TRANS/WP.29/845
8 May 2002

World Forum for Harmonization of Vehicle Regulations (WP.29)

DRAFT SUPPLEMENT 22 TO THE 03 SERIES OF AMENDMENTS
TO REGULATION No. 37

(Filament lamps)

Sheet H14/1

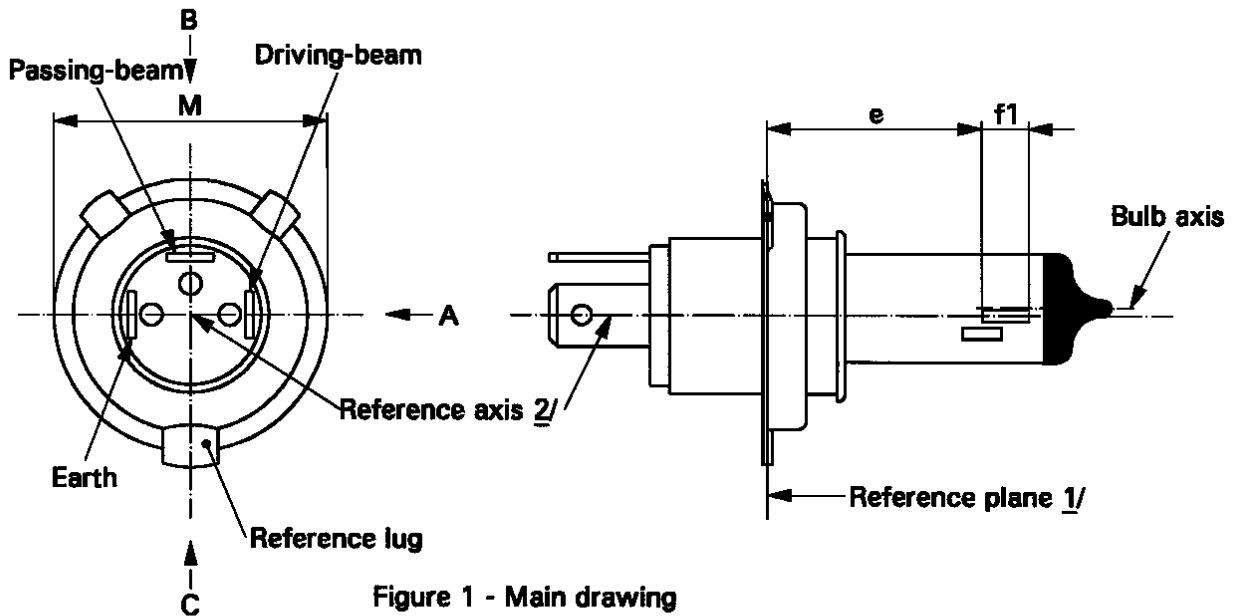
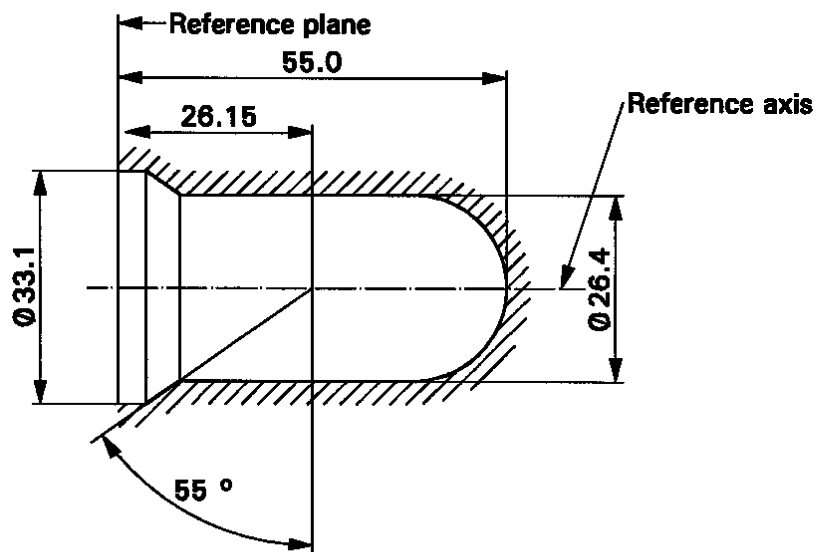
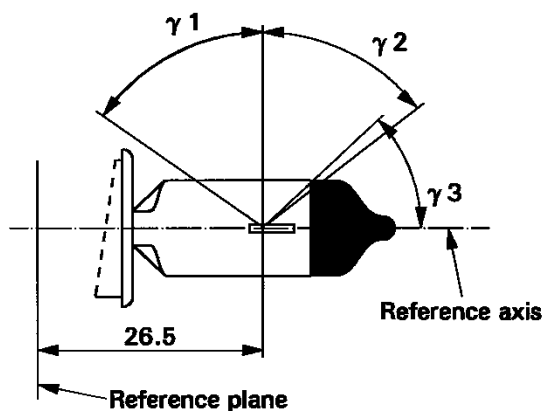
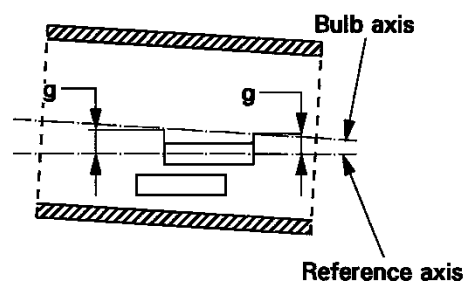
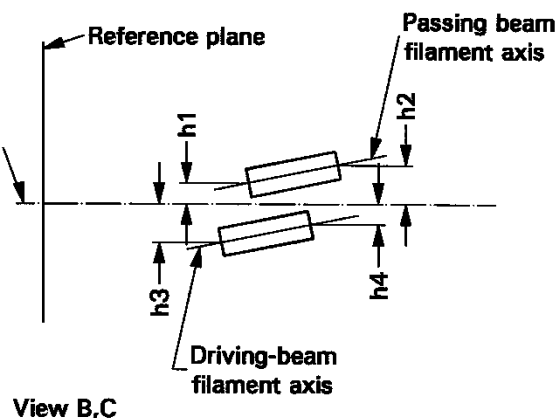
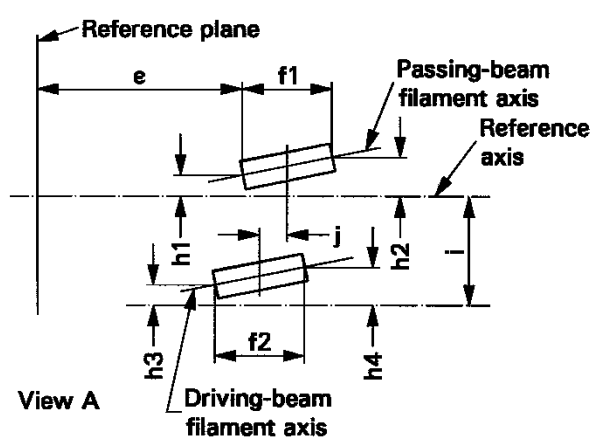
Add at the end new data sheets H14/1 to H14/4, to read:

- 1/ The reference plane is defined by the points on the surface of the holder on which the three lugs of the cap ring will rest.
- 2/ The reference axis is perpendicular to the reference plane and passing through the center of the cap ring diameter 'M'.
- 3/ Glass bulb and supports shall not exceed the envelope as indicated in figure 2. The envelope is concentric to the reference axis.

- 4/ Glass bulb shall be optically distortion free within the angles γ_1 and γ_2 . This requirement applies to the whole bulb circumference within the angles γ_1 and γ_2 .

- 5/ The obscuration shall extend at least to angle γ_3 and shall extend at least to the cylindrical part of the bulb on the whole bulb top circumference.

- 6/ Eccentricity of bulb with respect to passing-beam filament axis is measured in two planes parallel to the reference plane where the projection of the outside of the end turns nearest to or furthest from the reference plane crosses the passing-beam filament axis.

- 7/ The offset of the filaments with respect to the reference axis is measured only in viewing direction A, B and C as shown in figure 1 on sheet H14/1. The points to be measured are those where the projection of the outside of the end turns nearest to or furthest from the reference plane crosses the filaments axis.
